PLANNING REPORT

PLANNING AND ZONING COMMISSION

2. Ballantrae – Entry Features 08-096AFDP

Baronscourt Way, Larne Drive, Barronsmore Boulevard Amended Final Development Plan

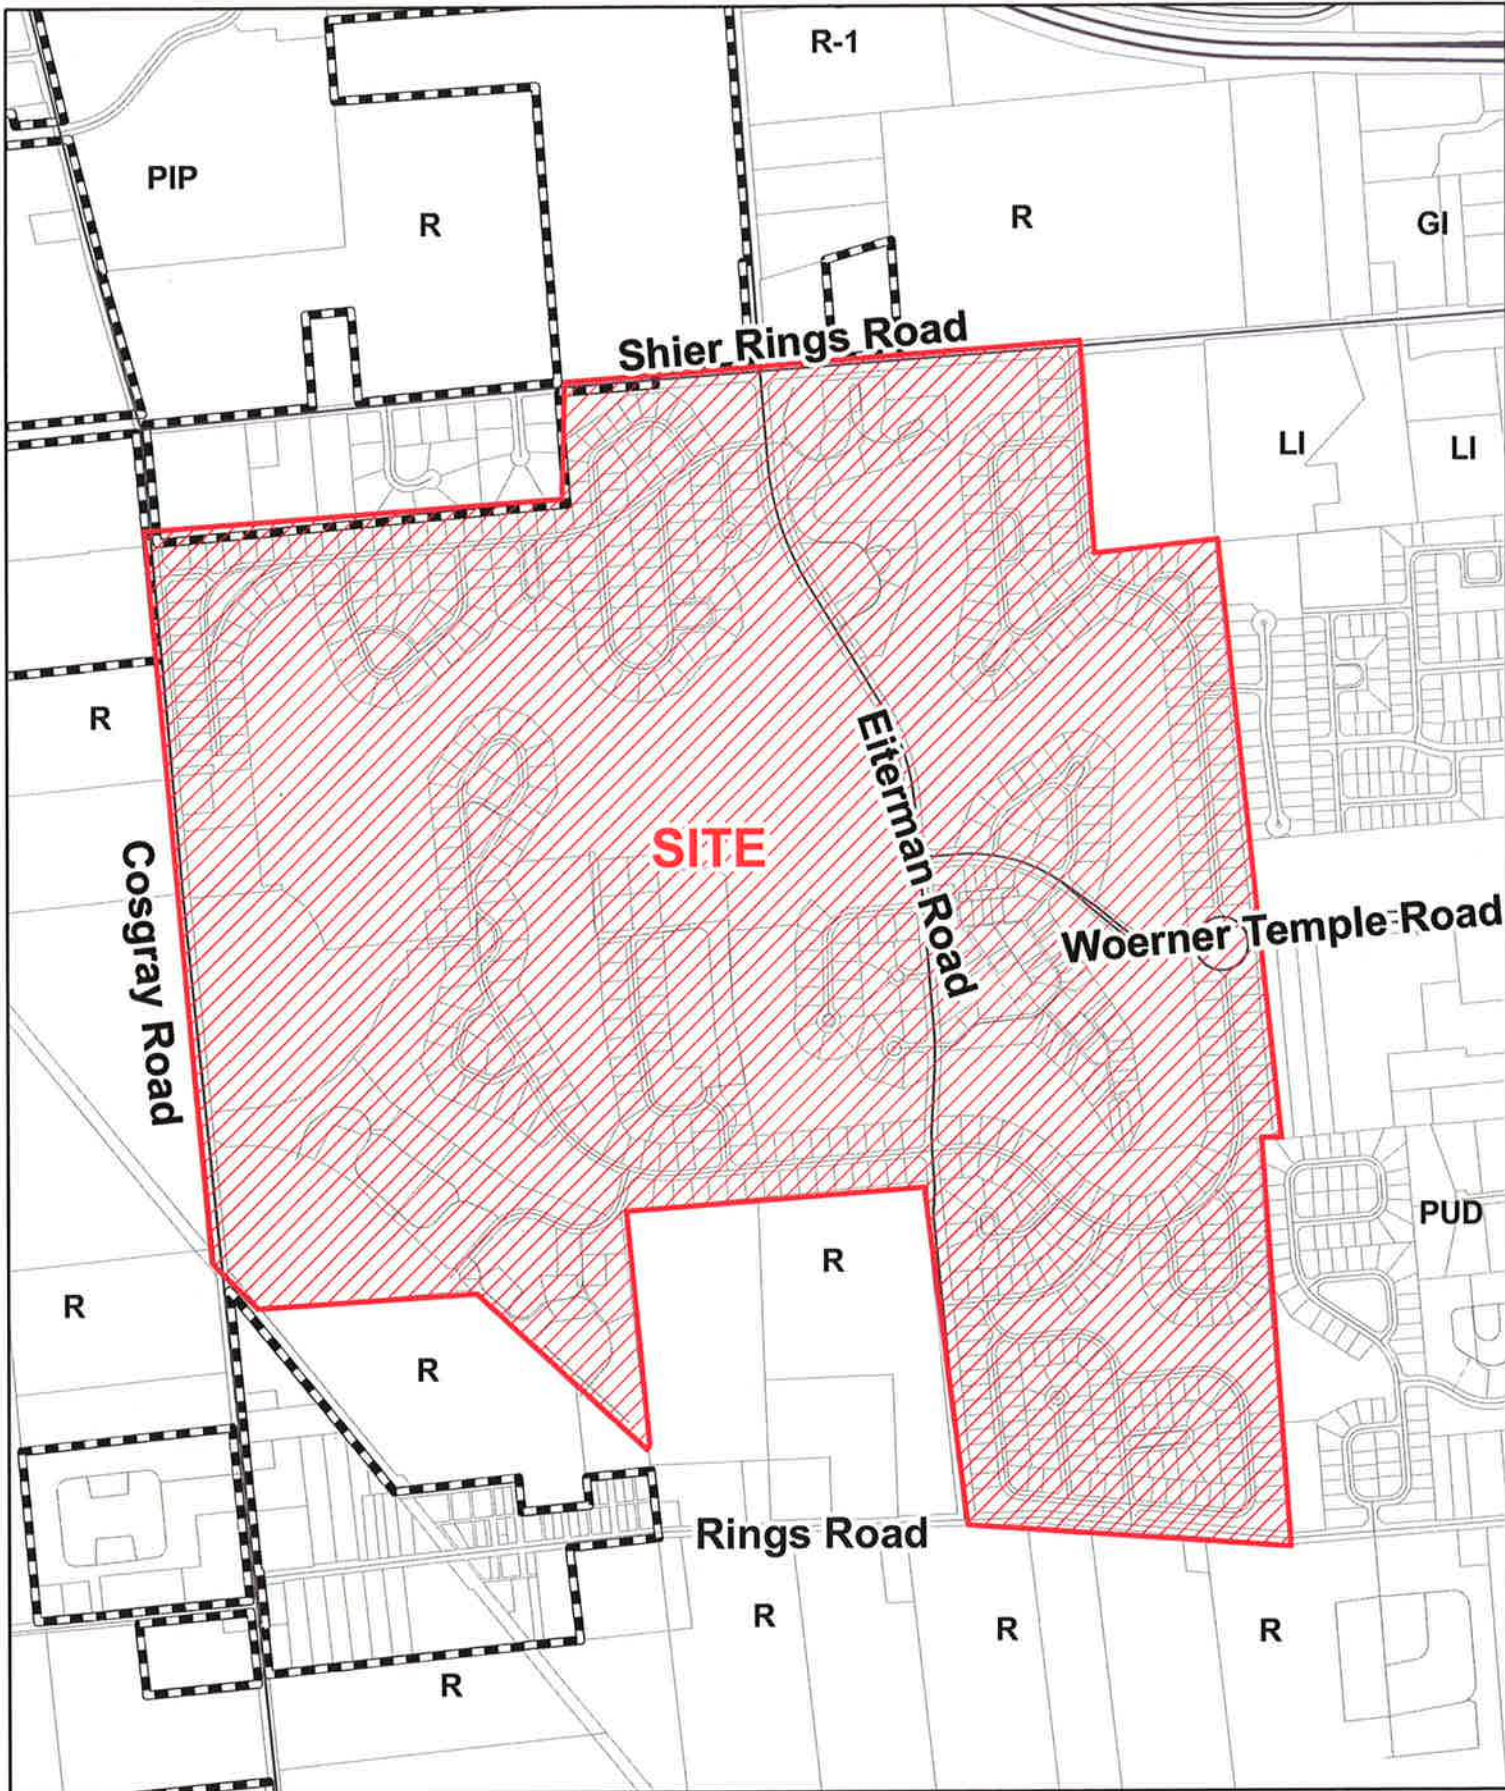
Criteria met through conditions: The proposal is sensitive to the natural characteristics of the site and adequately provides for all applicable stormwater provisions. The materials used for the proposed landscaping and entry features are consistent with other Sections of Ballantrae. The height of the engraving must be no higher than six feet from grade (Condition 1). Any entry feature lighting, if provided, will be subject to approval by Planning (Condition 2).

In Planning's opinion, this proposal meets the amended final development plan criteria and the development standards within the approved development text. Therefore, Planning recommends approval of this application with the following two conditions:

- 1) The height of the engraving is no greater than six feet from grade; and
- 2) Any entry feature lighting, if provided, will be subject to approval by Planning
